REMARKS

In the drawings:

Fig. 1

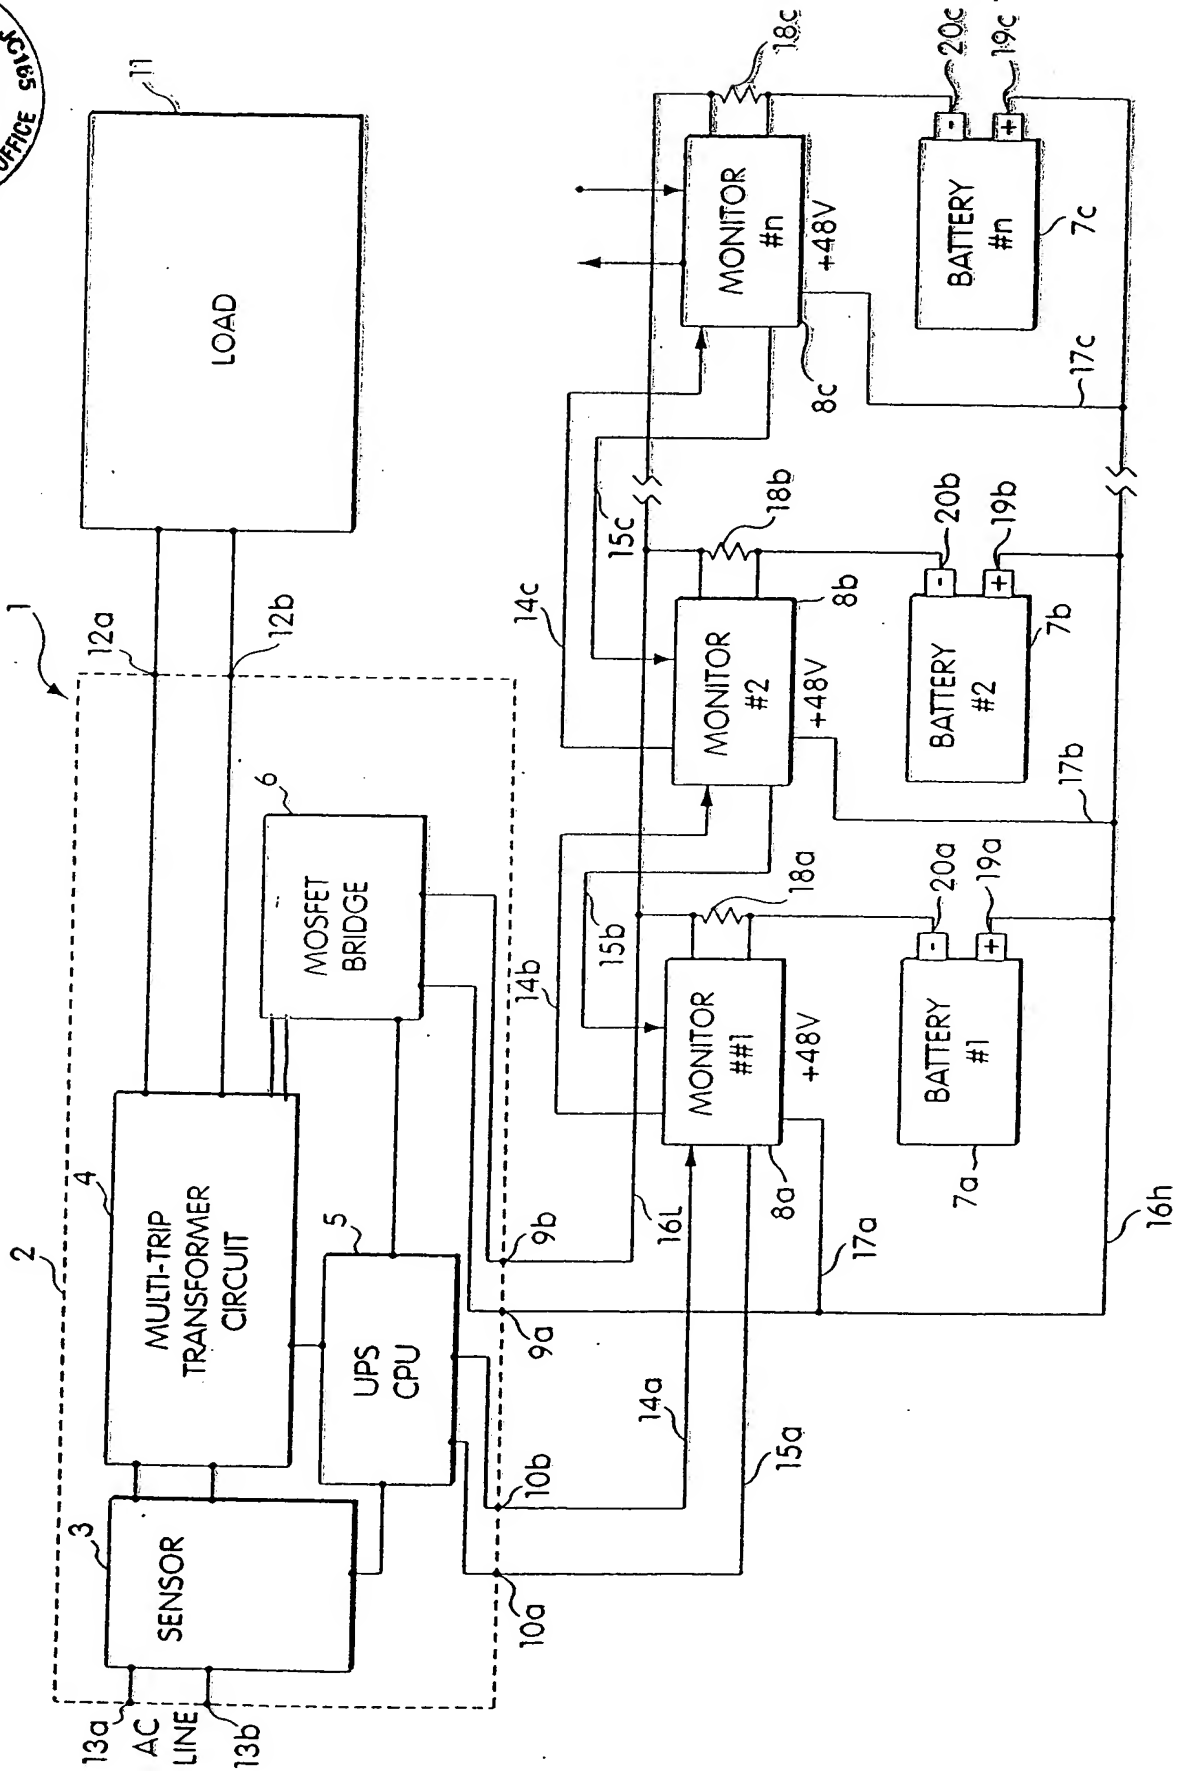
In FIG. 1, add two connections from MOSFET bridge 6 to multi-trip transformer circuit 4 as shown in red ink.
